102-02159-WFC/DAF  
May 27, 1992

**Subject: Palo Verde Nuclear Generating Station (PVNGS)  
Units 1, 2, and 3  
Docket Nos. STN 50-528/529/530  
Proposed Setpoint Tolerance Changes for PSVs and MSSVs  
File: 92-056-026**

**APS RESPONSE SUPPORTING PROPOSED SETPOINT TOLERANCE CHANGES  
FOR PVNGS PSVs AND MSSVs**

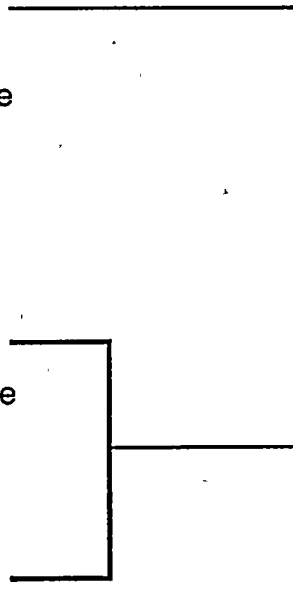
2. APS has reviewed and continues to review the offsite testing procedures from Wyle Laboratories, Dresser, and Westinghouse. These reviews, including a review of testing procedures from other utilities, have resulted in a revision to the PVNGS offsite testing procedure in order to change valve seat leakage requirements. The new test instructions require PSVs and MSSVs to be seat leakage tested with steam at 93% of the set pressure instead of 90%. This will reduce the possibility of challenging the relief valve. Using the PSVs as an example, the following pressure characteristics are noted:

From the diagram shown on the previous page, it is clear that if the operating pressure is increased above the normal operating pressure of 2250 psia, the operating range of 250 psi would be reduced. In addition, if the seat leakage test was performed at less than 2325 psia, then the seat leakage range would be reduced as well. Both of these actions increase the potential for seat leakage which over time will deteriorate the seating surfaces. If not corrected, the disc seat will erode and the valve lift pressure will become erratic due to the varying seat area.

APS has verified for Units 1 and 2 (Unit 3 to be verified in the fall of 1992) that the valves have an operating range (during offsite testing) within the requirements given in the above example. Therefore, the potential for reduced disc seat force has been lessened for these valves.

**FIGURE 3**  
**PRESSURIZER WATER VOLUME vs. TIME FOR LOCV EVENT**  
**WITHOUT PROPOSED TECHNICAL SPECIFICATION AMENDMENTS**

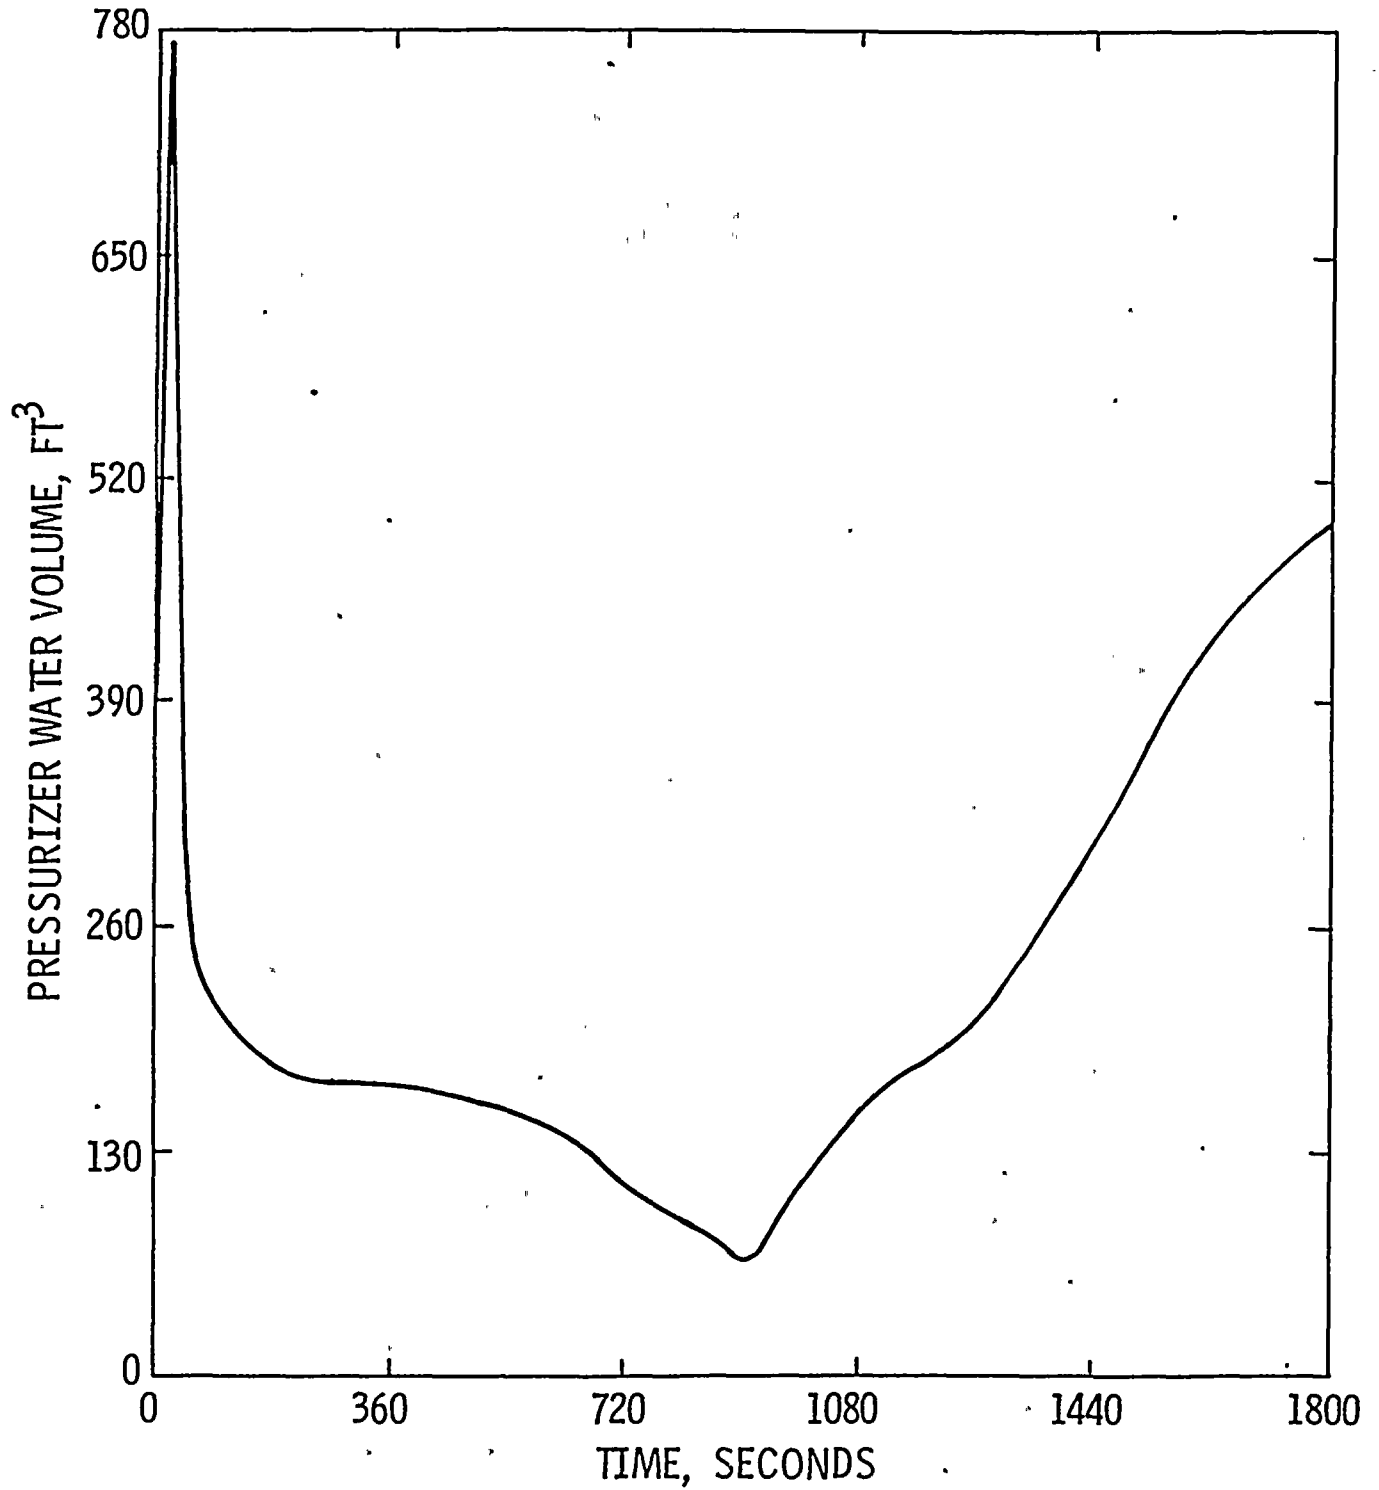
**NRC QUESTION No.7:**

Discuss whether the pressurizer would fill upon the safety valves opening later.

The pressurizer water volume for the LOCV event relating to the requested Technical Specification change is shown in Figure 2 (attached). Since the case under consideration was run for only 20 seconds, no data is presented for times greater than 20 seconds. Figure 3 (attached) presents UFSAR results for CE System 80 plants and PVNGS cycle 1 cases. A comparison reveals that peak pressurizer water volume of less than 780 ft<sup>3</sup> occurred at about 15 seconds in the UFSAR analysis as compared to a peak of 853 ft<sup>3</sup> at about 15 seconds in the present analysis. Thus the pressurizer level is well below the 1800 ft<sup>3</sup> level where the valve will be subject to blowdown water. The initial volume of the pressurizer is selected at 488.8 ft<sup>3</sup> (26% of the wide range) instead of the normal volume of 938.8 ft<sup>3</sup> at 100% power. A lower initial pressurizer volume maximizes RCS peak pressure. Thus the LOCV analysis sets all initial conditions to maximize RCS peak pressure.
